AIR STRUT - TOP PLATE

FIGURE 1

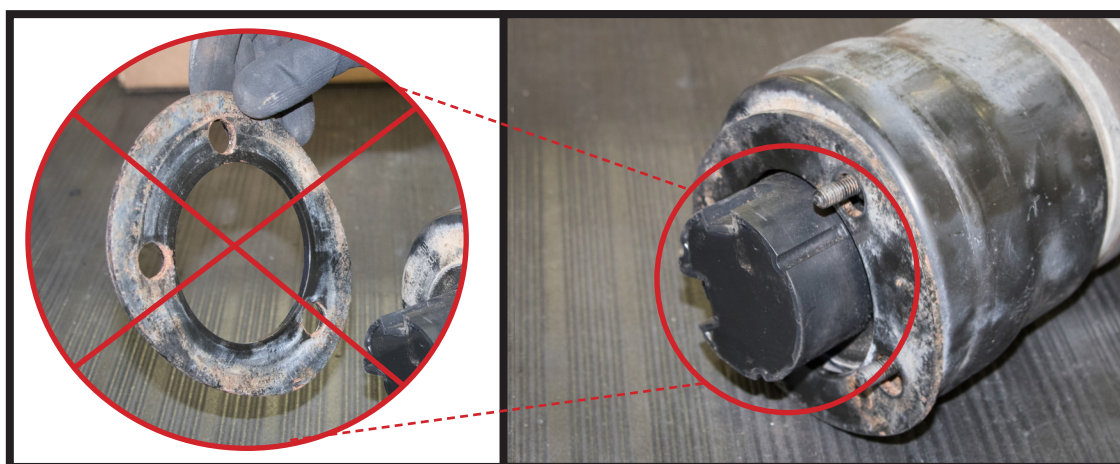
1. DO NOT REUSE FACTORY TOP PLATE. (FIGURE 1)

ARNOTT'S TOP MOUNT DESIGN INCORPORATES FLUSH MOUNTED FASTENERS, AS OPPOSED TO THE SURFACE MOUNTED FASTENERS ON THE OE ASSEMBLY WHICH REQUIRED THE USE OF A SHIM PLATE TO LEVEL THE MOUNTING SURFACE.
